REVISED 12/10/2025**ADDRESS: 1815 SEMINOLE****APPLICATION NO: #HDC 2025-00473-#HDC2025-00705****HISTORIC DISTRICT: INDIAN VILLAGE****APPLICANT: ALISSA JACOBS (4545 ARCHITECTURE)****OWNER: RACHEL AND TROBAUGH NELSON****DATE OF STAFF SITE VISIT: 11/20/2025****DATE OF PROVISIONALLY COMPLETE APPLICATION: 11/17/2025****SCOPE: REPLACE WINDOWS****EXISTING CONDITIONS**

Photo provided by applicant. Note that the transoms panes appear to be slightly more inset within the opening than the operable sash. Staff notes that the submitted drawings do not provide dimensions of the top portion of the existing casement window frame (see yellow arrows).

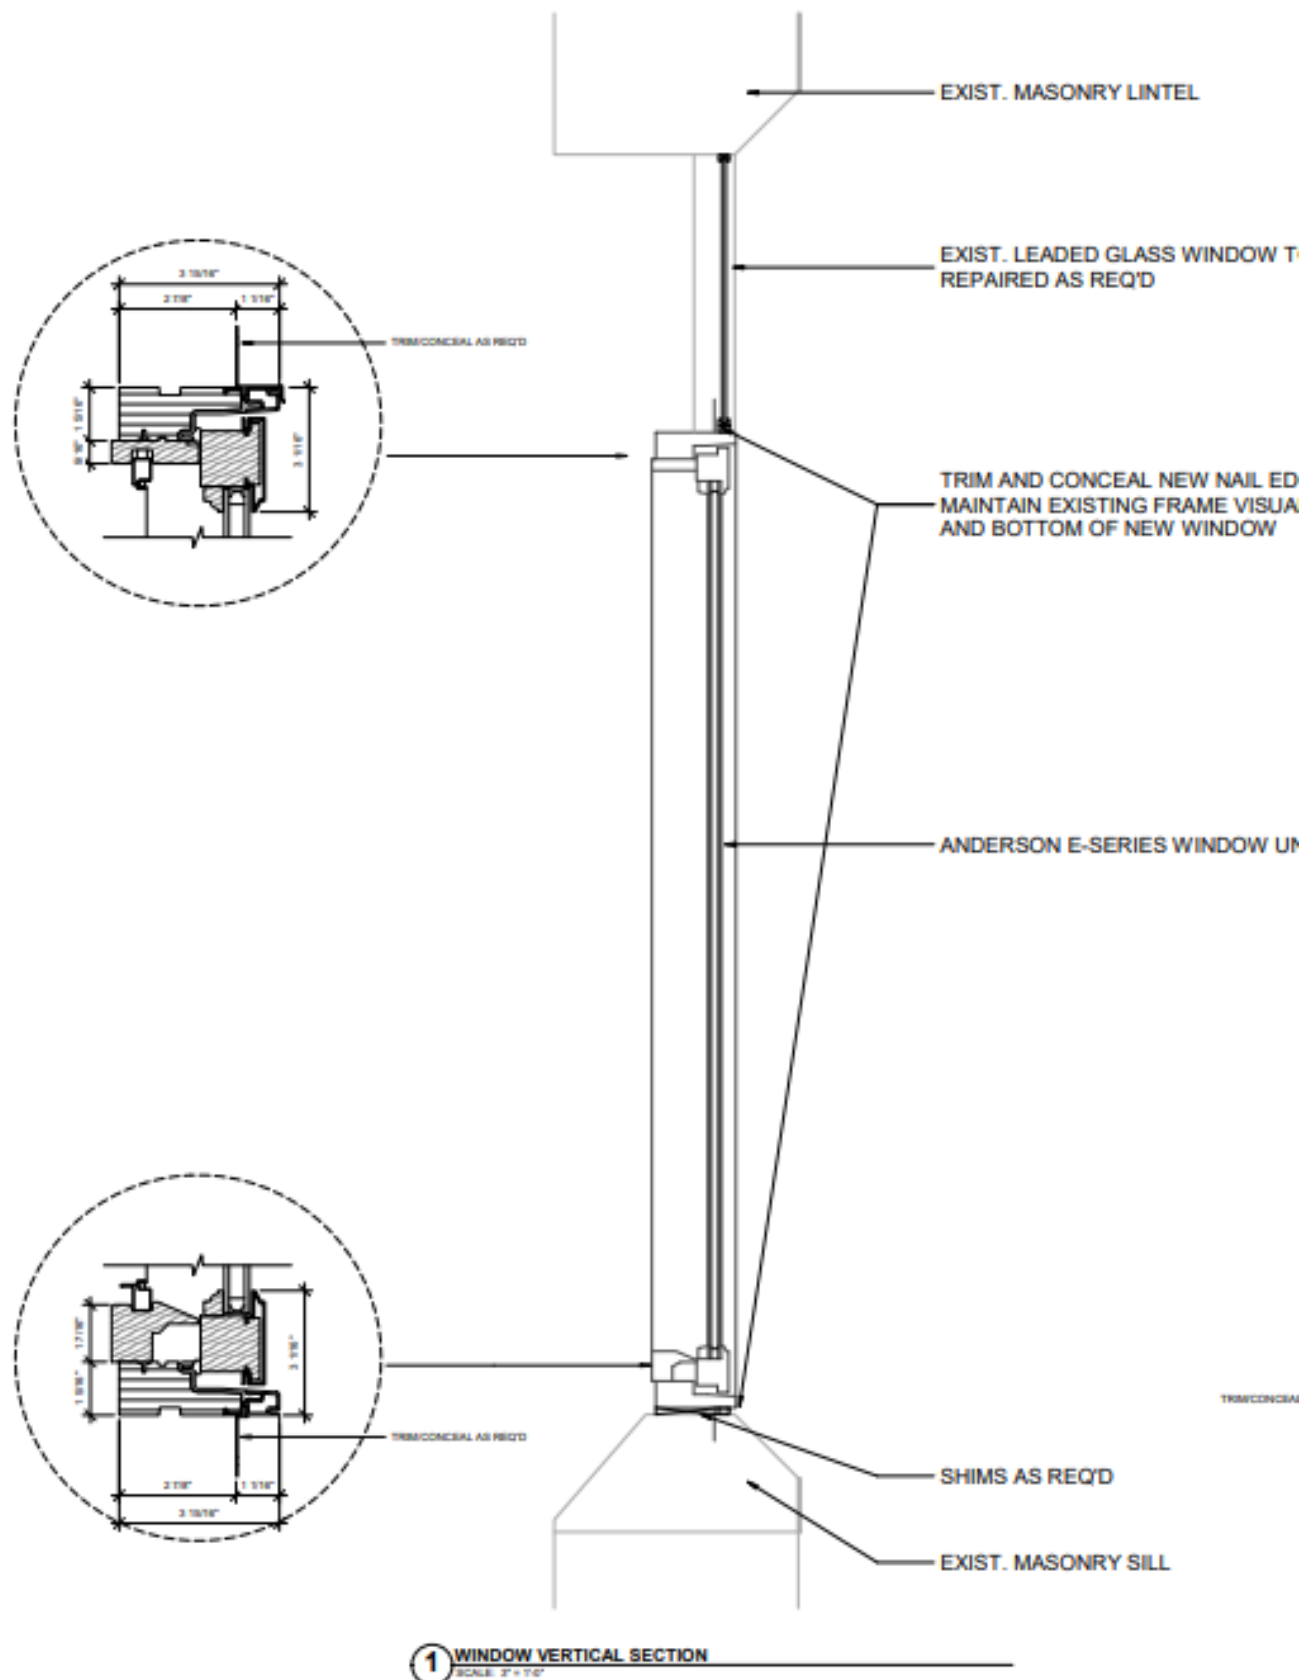
- See the below photos drawings which the applicant submitted in response to the above request. Staff notes that the submitted drawings do not adequately document the existing conditions/dimensions at the top and bottom portion of the frame to compare to the proposed. However, a review the below horizontal sections (drawings #2 and #3) revealed that the side portions of the frame for the proposed new windows will be significantly wider than the existing. Also, each of the proposed new casement windows will include a single, undivided panel of glass while the existing casement units are divided to include four panes of glass each. Staff therefore concludes the proposed casement windows are not an adequate match to the existing historic steel units
